Ref: LCR 90-09

PROPOSED TECHNICAL SPECIFICATIONS AND BASES CHANGE

PROPOSED CHANGE TO THE TECHNICAL SPECIFICATIONS FACILITY OPERATING LICENSE NPF-57 HOPE CREEK GENERATING STATION DOCKET NO. 50-354

2.1.1 THERMAL POWER, Low Pressure or Low Flaw

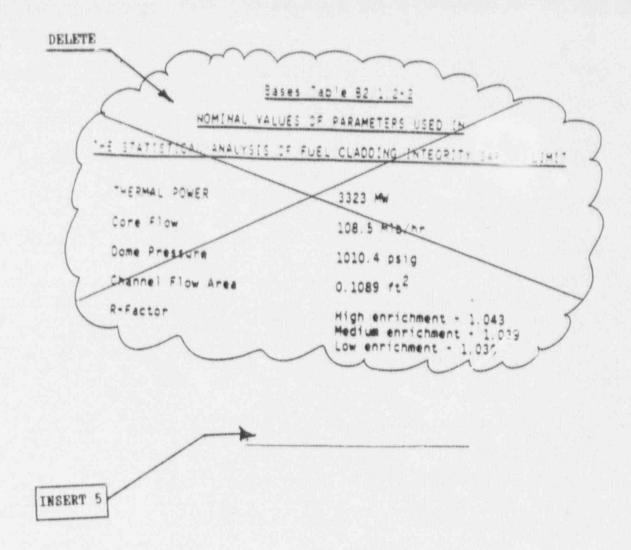
INSERT 1

The use of the Correlation is not valid for all critical power calculations pressures below 785 psig or core flows less than 10% of rated flow. Therefore, the fuel cladding integrity Safety Limit is established by other means. This is done by establishing a limiting condition on core THERMAL POWER with the following basis. Since the pressure drop in the bypass region is essentially all elevation head, the core pressure drop at low power and flows will always be greater than 4.5 psi. Analyses show that with a bundle flow of 28 x 10³ lbs/hr, bundle pressure drop is nearly independent of bundle power and has a value of 3.5 psi. Thus, the bundle flow with a 4.5 psi driving head will be greater than 28 x 10³ lbs/hr. Full scale ATLAS test cata taken cal power at this flow is approximately 3.35 Mwt. With the design peaking factors, this corresponds to a THERMAL POWER of more than 50% of RATED THERMAL POWER. Thus, a THERMAL POWER limit of 25% of RATED THERMAL POWER for reactor pressure below 785 psig is conservative.

INSERT 1

applicable NRC-approved critical power
